DC/20/05507- Land Adjacent To Brome Grange Hotel – Highways Statement

I refer to your request for highway advice concerning your proposal for development on this site principally for the erection of commercial units, accessed off A140 and utilising the existing access of Brome Grange Hotel. For latest Site Layout Plan, Drawing TAB550-02E, refer Appendix A.

Review of SCC Highways consultation response

Screen shot 1: Existing access (Source: Google street view)

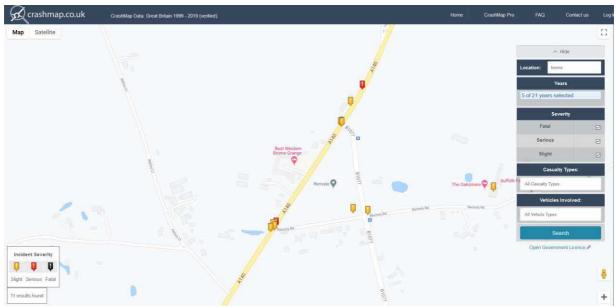
The proposed commercial use will utilise the existing access as viewed in the screen shot below.

The latest drawing TAB550-02E, as set out in Appendix A now demonstrates the achievement of the required visibility splays. In fact, a greater visibility is achieved than that required by SCC, achieving x=4.5 m and Y=120 m, is shown as achieved (refer drawing note 5.). Given the required dimensions can be met, the proposed vehicular access will safely facilitate the intensification of use the development would create. This will therefore be acceptable to SCC and meet their safety standards.
